## **Normandy Action Group Objection to Planning Application 25/P/01726**

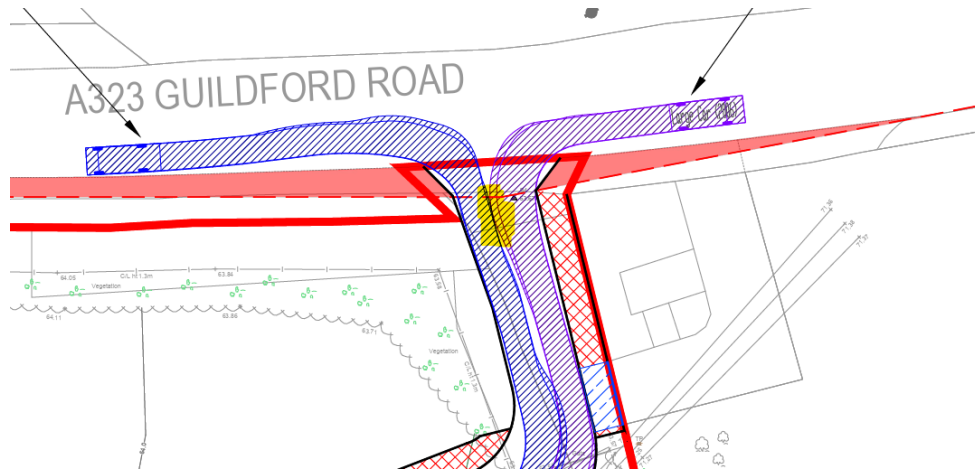
The Transport Statement (TS) notes that the vehicle tracking allows for a vehicle to wait in the entrance to the SANG Carpark while another vehicle enters but the swept path diagram (see below) clearly shows the front of the entering vehicle sliding down the side of the outgoing waiting vehicle. This is compounded by the fact that the A323 is a busy road with high volumes of traffic (see below about the lack of a Road Safety Audit or speed survey).
